# Federal Aviation Administration

## Memorandum

Subject: Extension of Equivalent Level of Safety (ELOS) ACE-07-11 to include the Cessna Model J182T with the SMA Model SR305-230-E Compression Ignition Engine.

ELOS Memo #: ACE-07-11A

FIGURE 1

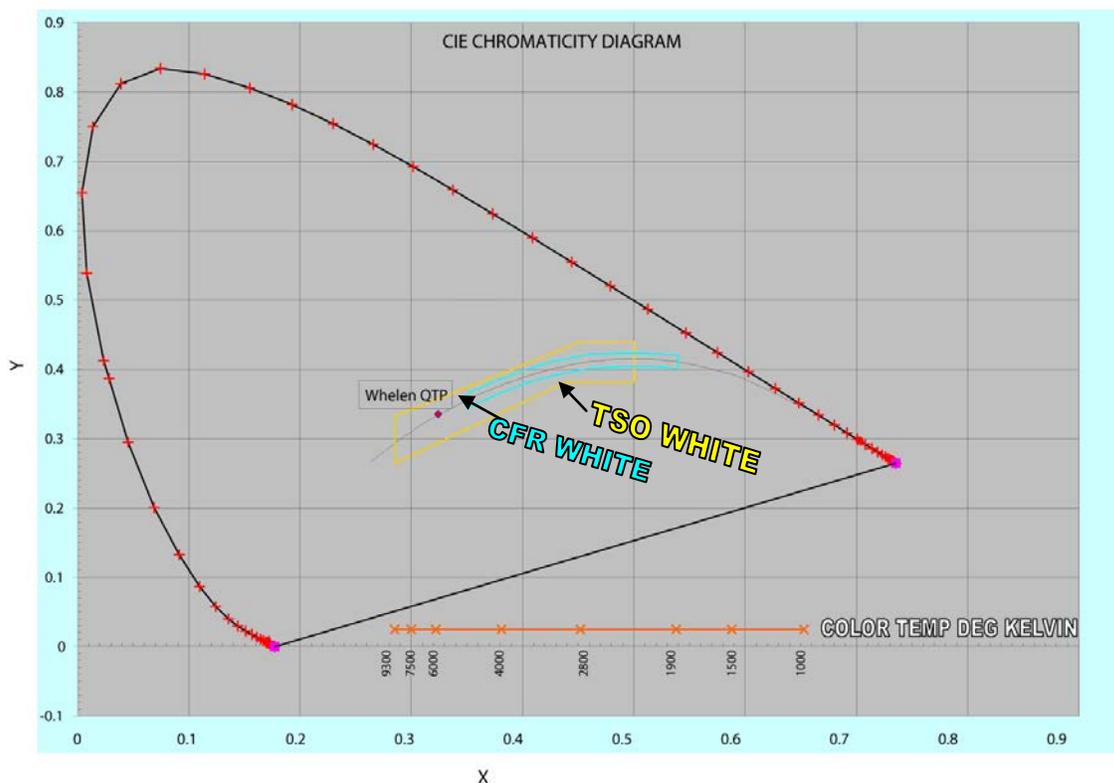
The diagram (Figure 1) shows the boundary of § 23.1397(c), amendment 23-0 requirements and the boundary permitted by TSO-C30c. The TSO boundary, dictated by the AS8037 requirements has a significant overlap with the § 23.1397(c), amendment 23-0 requirements,

however, there are portions of the two requirements that do not overlap. Since the requirement to produce the lights is defined by AS8037, Cessna believes that while some light assemblies might meet the requirements of § 23.1397(c), per amendment 23-0, others might only meet the requirements dictated by the TSO, which would result in non-compliance.

The chromaticity requirements are intended to provide, within limits, a standardized perception of "white" to the human eye. The FAA considers that excursion from the § 23.1397(c), amendment 23-0 requirements for the LED color white, while remaining within the requirements provided by TSO-30c for the color white, provides a light that results in an ELOS to that required by the regulation. This determination is applicable for the part number listed above and

derivative parts from the same manufacturer whose chromaticity is the same as the one discussed here and used on the Cessna Models 182T and T182T. The ACO concurs that the new Cessna Model J182T rear position light configuration has been analyzed and provides an ELOS for § 23.1397(c), amendment 0.
